SEAS DEADLINE 6 RESPONSE to APPLICANTS's SUBMISSIONS
SINCE DEADLINE 5, ISH3, Action Points and ExQ3
LANDSCAPE & VISUAL and CULTURAL HERITAGE

PINS Ref: EN020026
DEADLINE 6: APRIL 13, 2026

EN020026 SEA LINK DCO – DL6: RESPONSE BY NICHOLAS BRIDGES

ZTV ANALYSIS – IP ref FA62B0DA

Figure 12. Sea Link EN020026-000339-6.4.2.1 ES Figures Suffolk Landscape and Visual Part 1 of 7, page 14
 REPRESENTATIVE VIEWPOINT LOCATIONS AND SCREENED ZONE OF THEORETICAL VISIBILITY - SEA LINK AND FRISTON SCENARIO 1

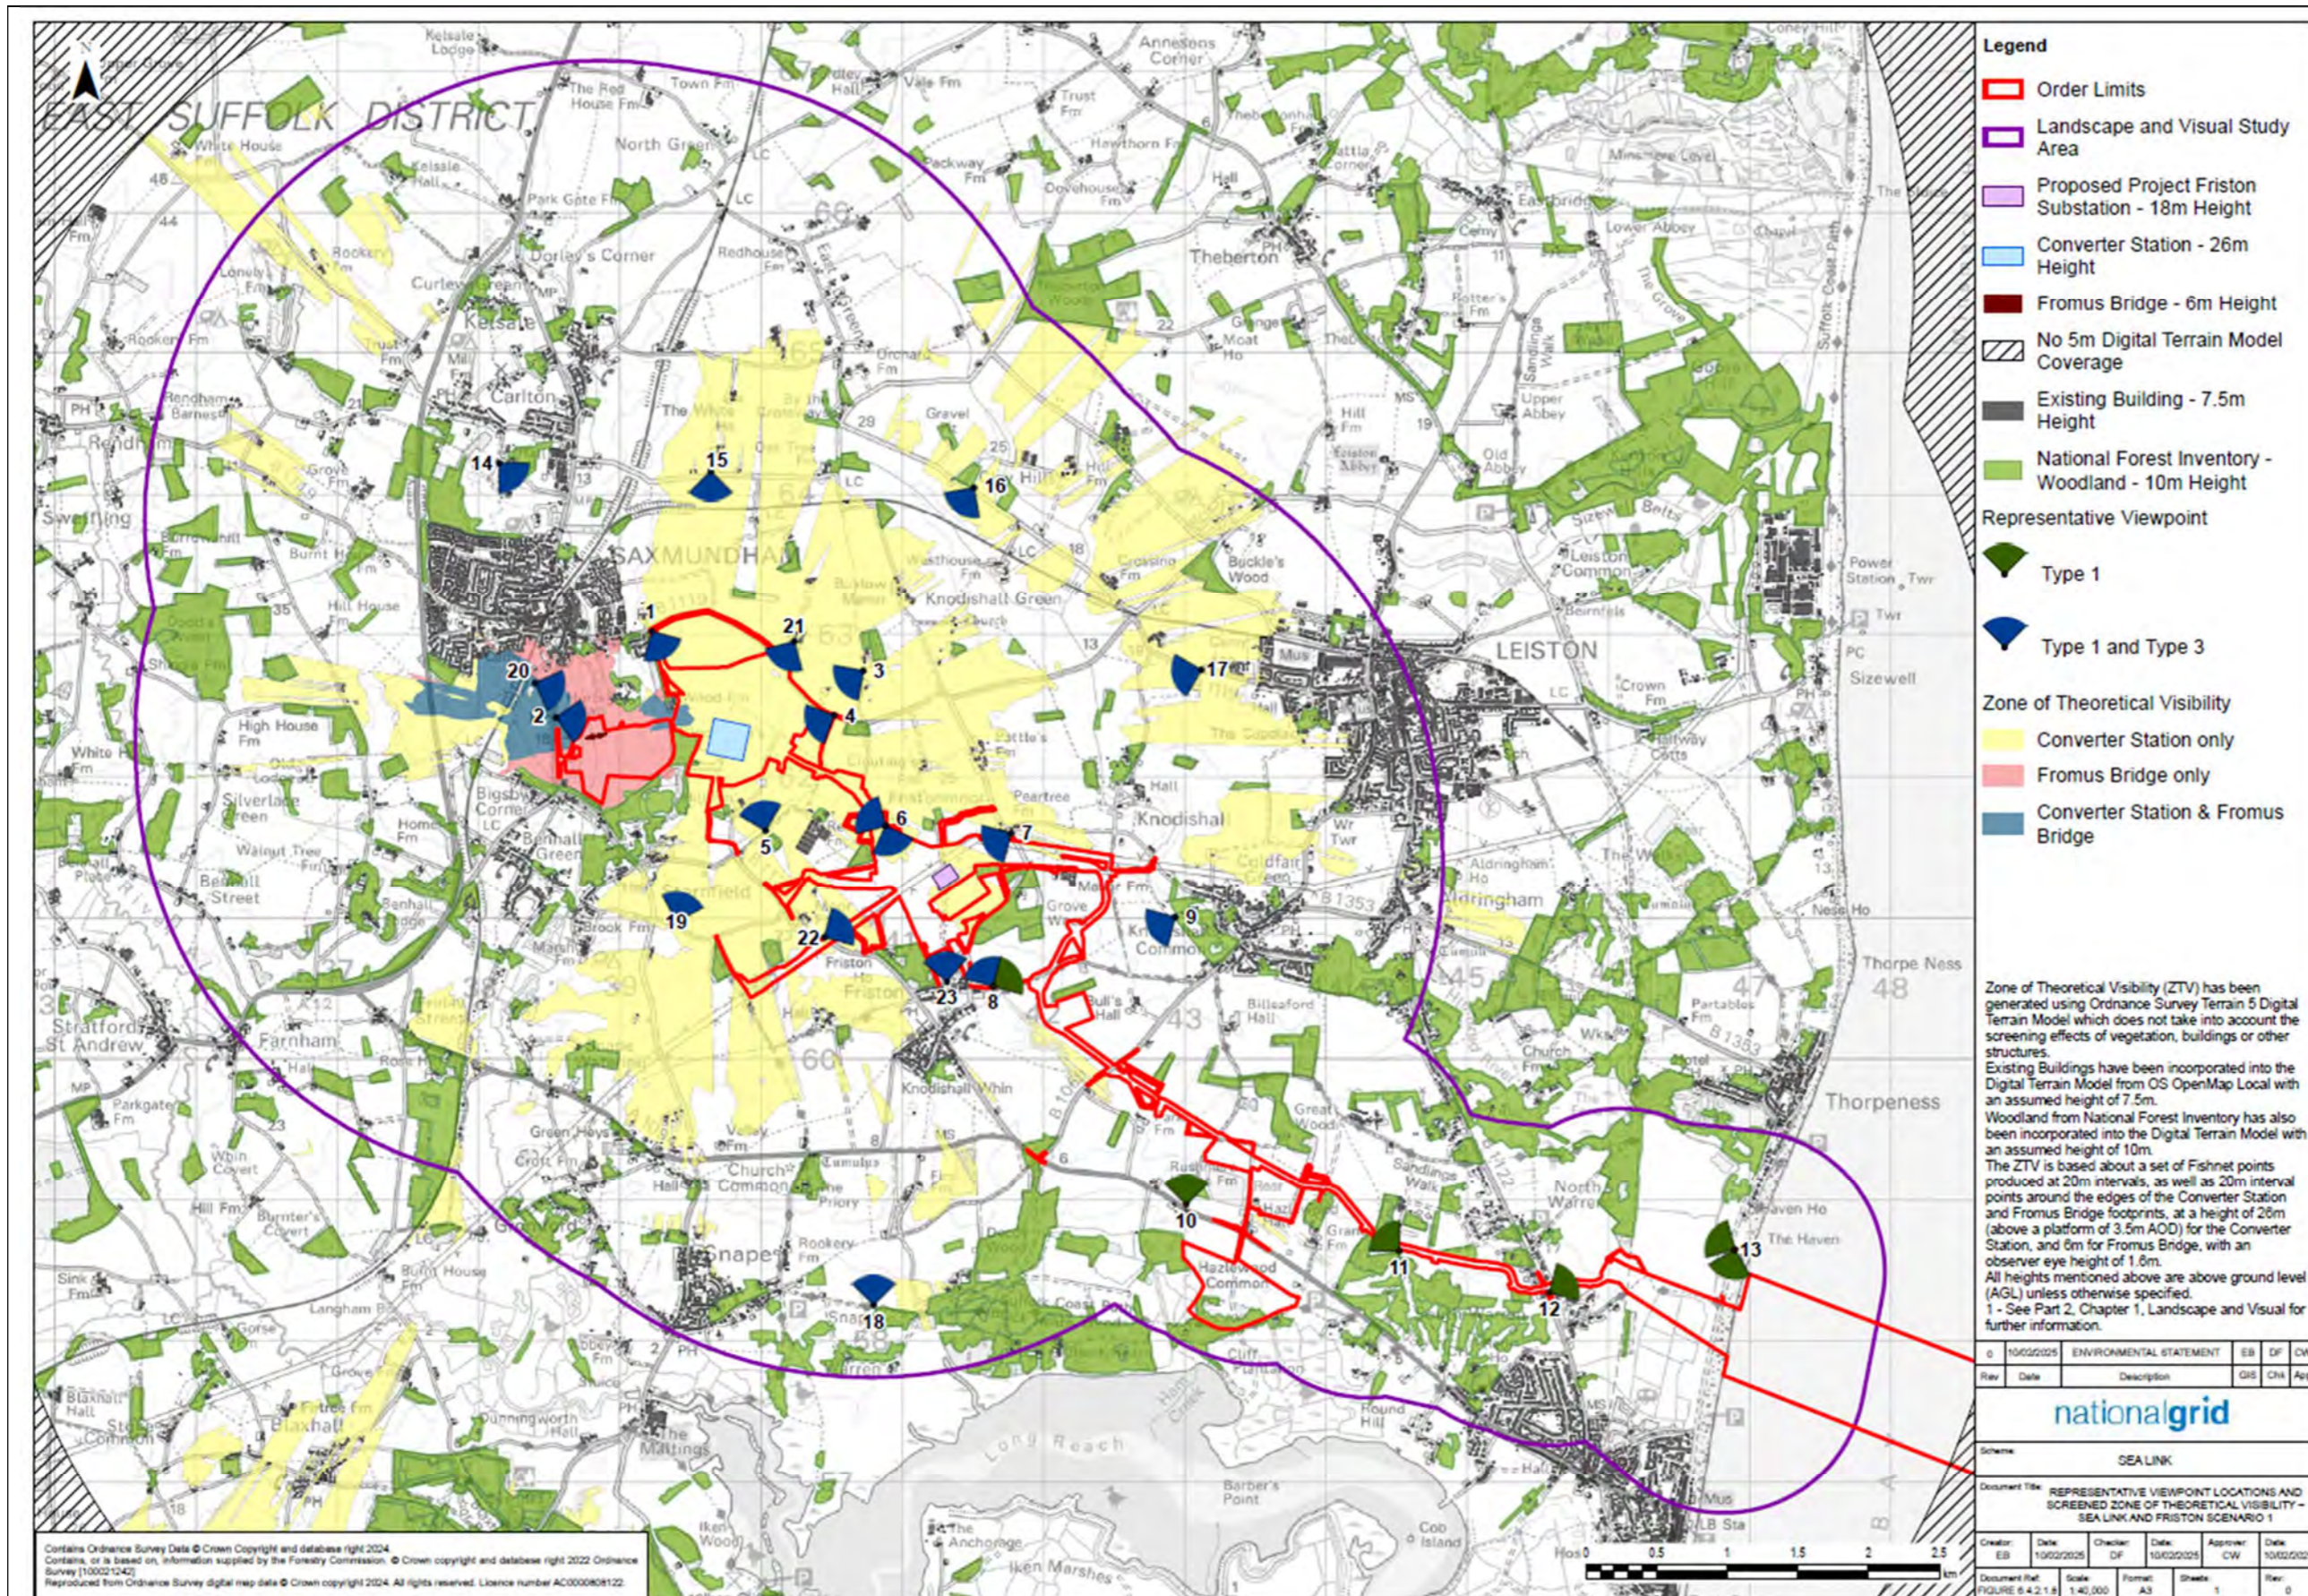
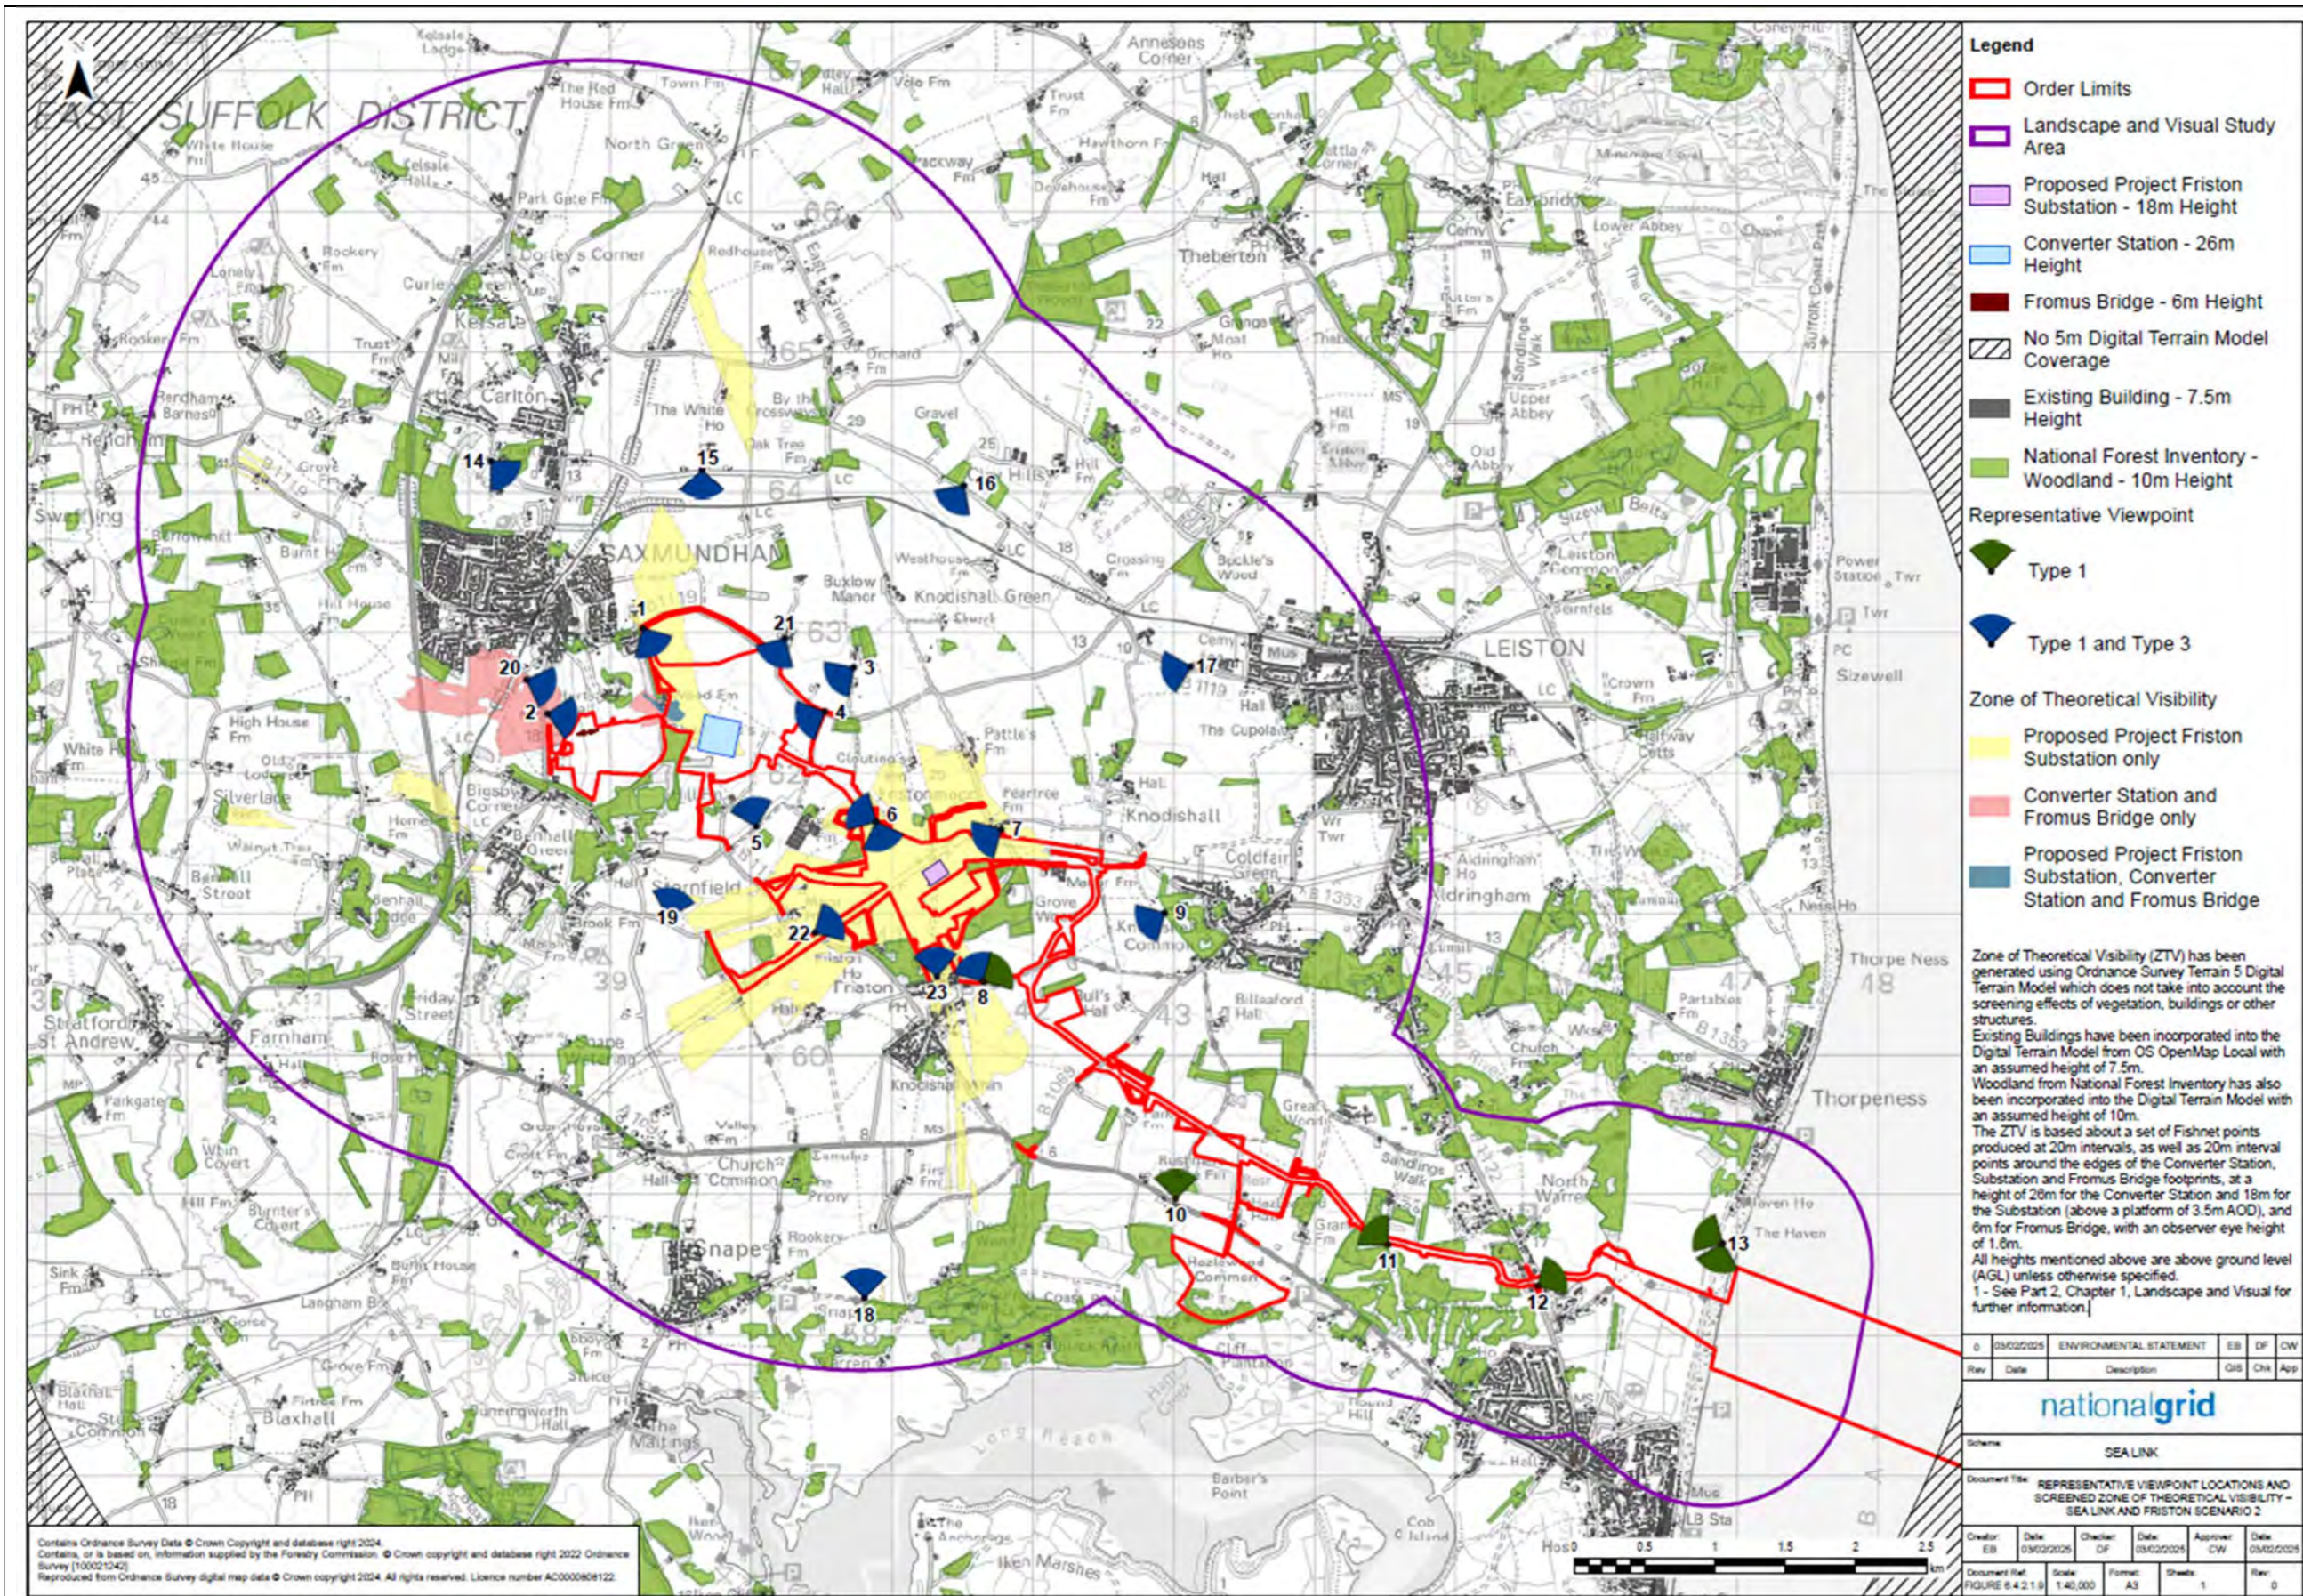
2.10. The 'shadow' patterns illustrate the 'shading' effects of woodland and buildings. The ZTV plans of the same proposed volumetric parameters (**Figures 12 to 17** below) show far less visibility than its PEIR ZTV plans. The accompanying textual details of the model's constraints are exactly the same (see the schedule below).

2.11. The **first question** is: why are the PEIR and DCO plans so completely different? Were the heights in the model changed? Were the shadowing criteria altered? Which is correct? If the DCO is correct, were the EA1N and EA2 ZTVs incorrect? These are simple technical points which can be explained easily.

- 3.1. The submitted DCO ZTV plans should be reviewed for their accuracy.
- 3.2. If they are correct, the applicant must explain why the PEIR was so different
